DEVIATION REQUEST AND DECISION FORM

Project Name : Hillside at Lorson Ranch
 Schedule No.(s) : 5500000370, 5500000371, 5500000405, 5500000281, 5500000282, & 5500000283
 Legal Description : See Attached

A deviation from the standards of or in Section 2.2.5 (E) of the Engineering Criteria Manual (ECM) is requested.

**DEVIATION 1
EXHIBIT**

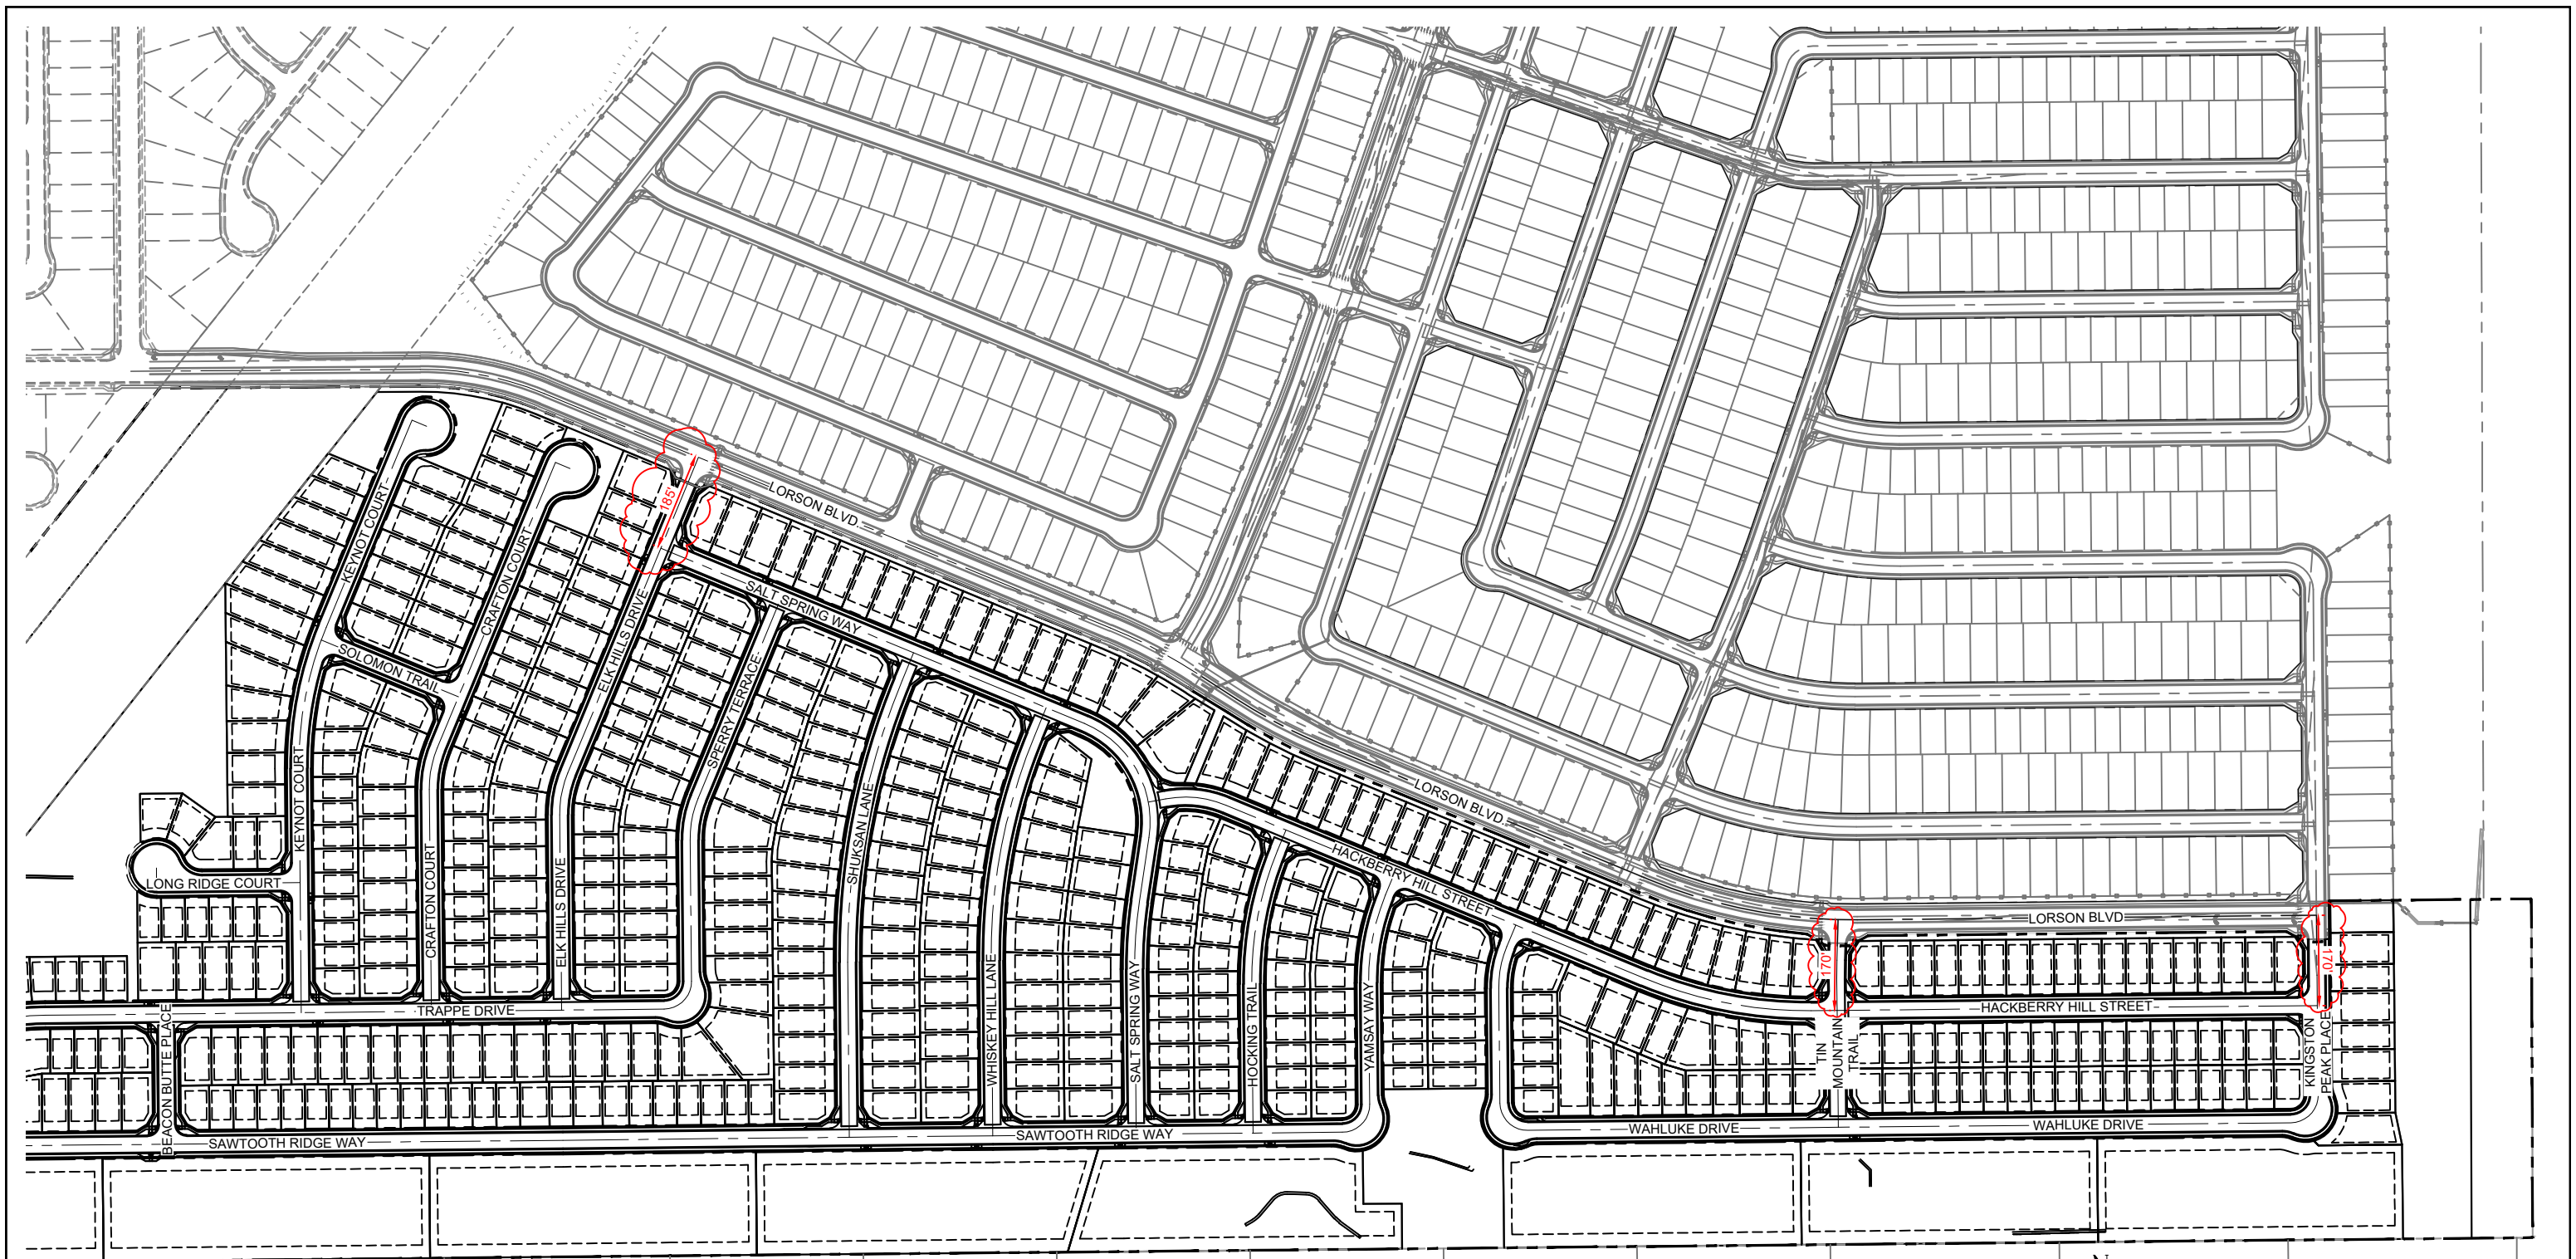
To permit urban local roadways and a collector roadway to intersect centerline to centerline closer than 200' at the intersections of Elk Hills Drive & Lorson Boulevard, Tin Mountain Trail & Lorson Boulevard, and Kingston Peak Place & Lorson Boulevard.

Lorsen Boulevard, the intersecting road, is proposed as a residential collector. Per the 200' spacing requirement, in order to meet the standard the lots would have to be 133'-135' deep in this instance. A 170'-185' intersection spacing is currently proposed at the three intersections along Lorson Boulevard.

The modification to permit roadway intersections less than 200' will not adversely affect safety or operations as these intersections are not designed as through streets, limiting traffic to residents. The intersection spacing as shown at the intersection of Kingston Place & Lorson Boulevard is 170'. The intersection spacing as shown at the intersection of Tin Mountain Trail & Lorson Boulevard is 170'. The intersection spacing as shown at the intersection of Elk Hills Drive & Lorson Boulevard is 185'. Given the limited traffic and cut through options, the shortened intersection spacing is not expected to cause any queuing constraints. In addition, pedestrian safety should not be comprised as any vehicle entering the site will have done so after a complete stop or near complete stop keeping speeds at a minimum when approach the intersection crossings.

This request has been determined to have met the criteria for approval. A deviation from Section 2.2.5 (E) of the ECM is hereby granted based on the justification provided.
